PREVOST

WARRANTY BULLETIN

WB12-31B

DATE : NOVEMBER 2012	SECTION : 01 - Engine
EXPIRATION: NOVEMBER 2014	
SUBJECT : DIPSTICK REPLACEMENT- D13 US07 AND US10

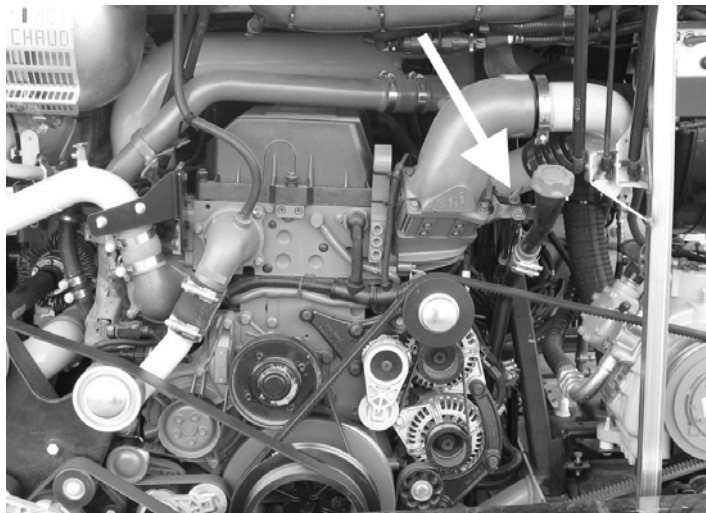
1. Locate the dipstick on the Engine

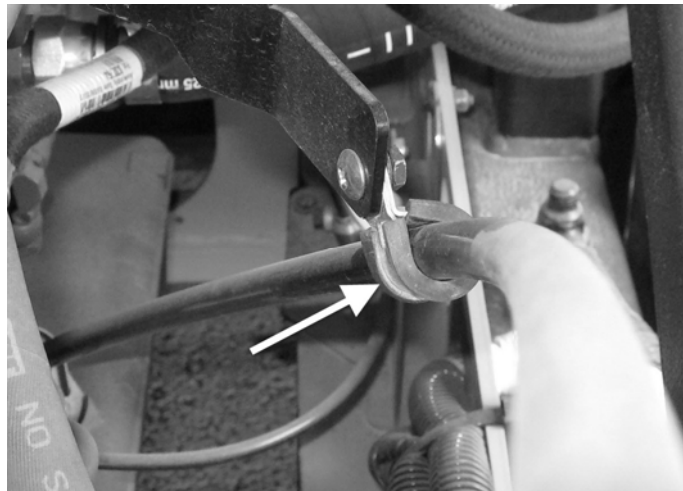
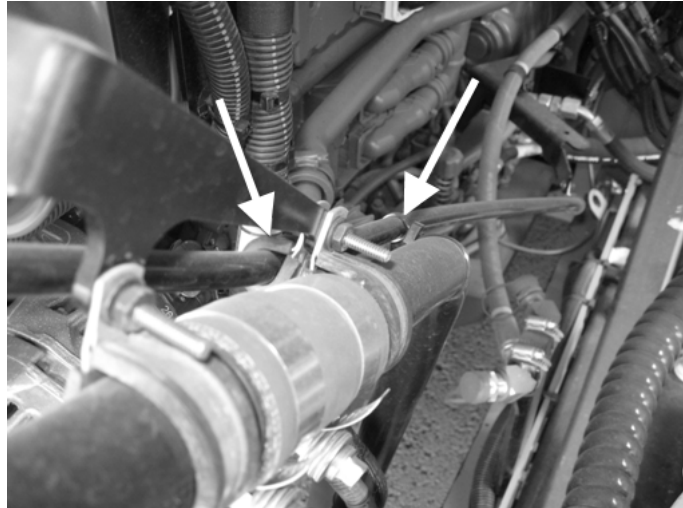
2. Start by removing this screw.
Reserve hardware for re-install

3. Follow the dipstick tube towards the oil pan and remove all clamps and one double loop cable tie.

Reserve clamps and hardware for re-install.

If the clamps and hardware are too corroded for re-use, replace them.

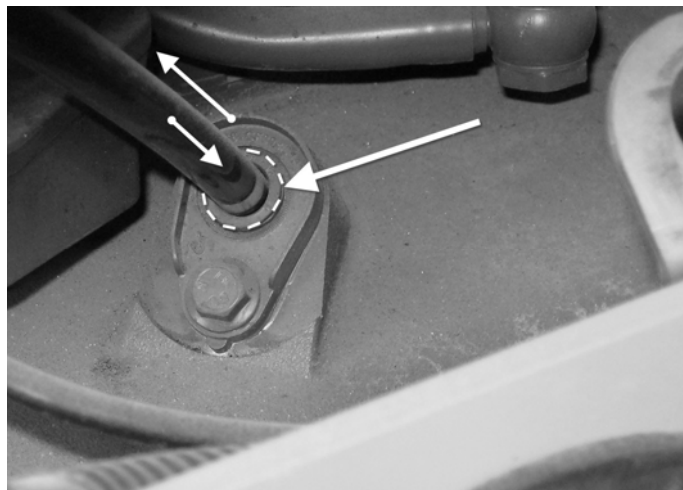
4. At the oil pan, depress ring.

Push tube in a jerk motion and then pull to release.

Movement to release tube is similar to disconnecting a pneumatic quick coupling connection.

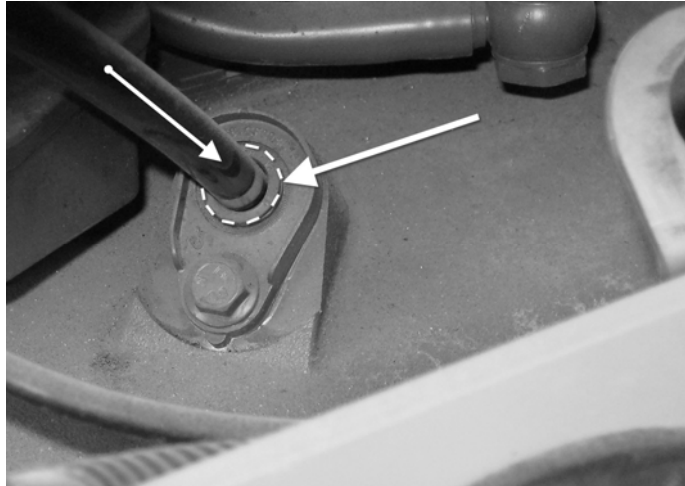
1. Insert new dipstick tube fully in oil pan coupling.

2. Secure the dipstick tube reusing the clamps and hardware removed earlier. Replace any part not suitable for re-install.

Hand tighten hardware.

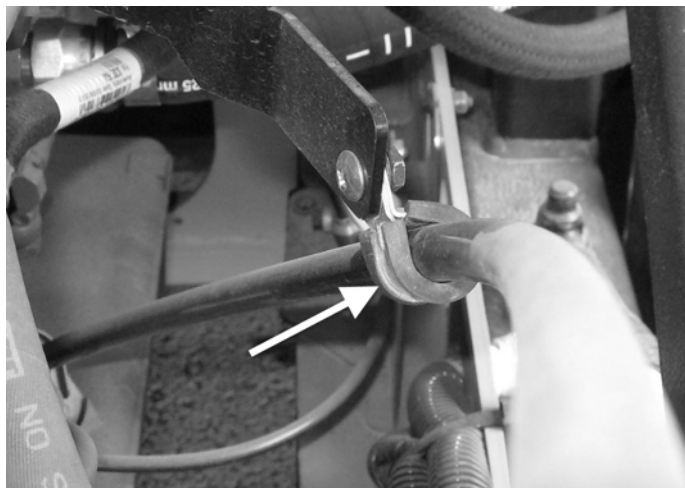
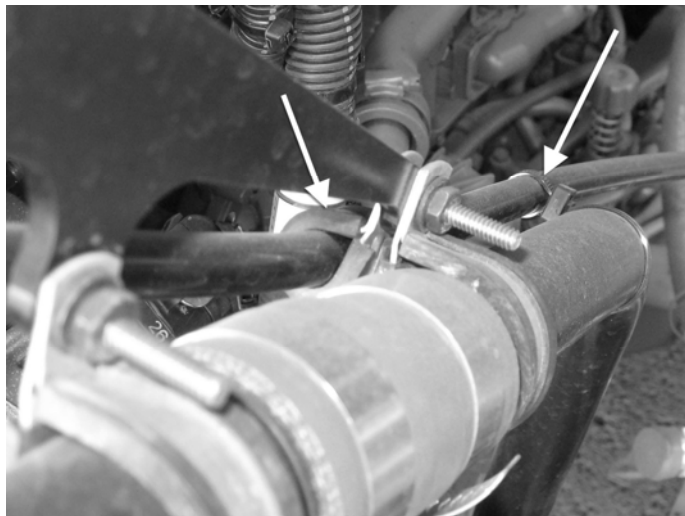
3. Install double loop nylon tie #507664.

4. Use reserved screw to secure handle end of new dipstick tube.

Lightly hand tighten screw to allow adjustment in following steps.

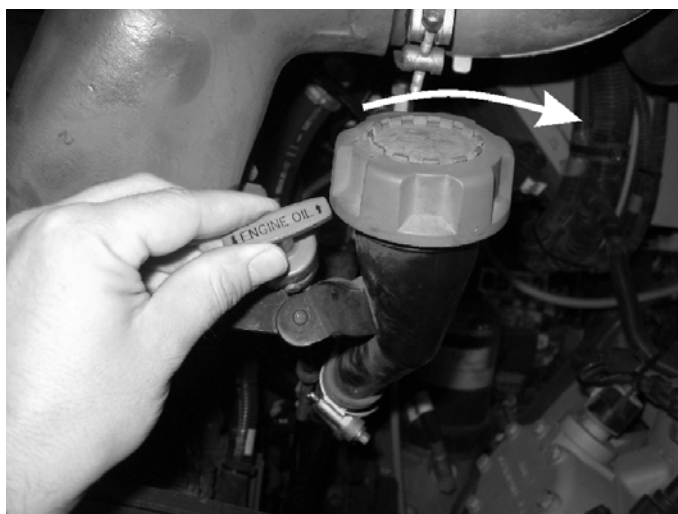
5. Fill tube will need to be rotated slightly away from new dipstick handle.

6. Slack tube collar and clamp at the flexible connection.

The flexible connection tends to stick to the fill tube. Gently insert a flat screwdriver to release and allow rotation of the fill tube.

7. Rotate fill tube to this suggested position.

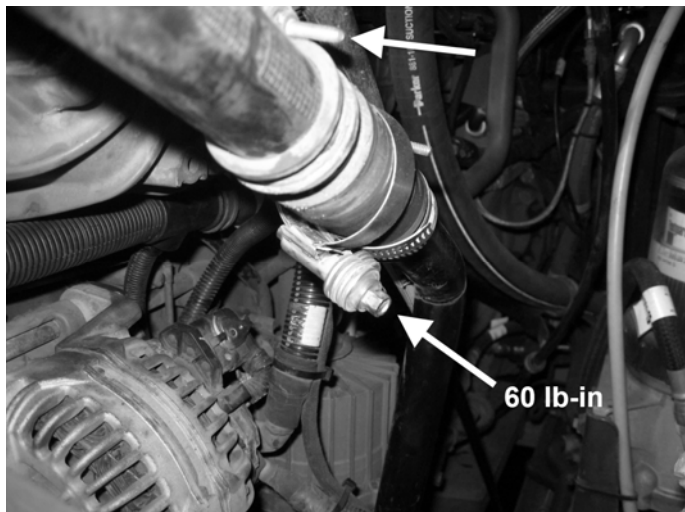
Ensure fill tube stays in position even if clamps are loose.

8. Make sure there is no remaining tension on the fill tube before tightening the collar and clamp.

Tighten collar to 60 lb-in

Hand tighten clamp

9. Hand-tighten screw 5001793 for final assembly.
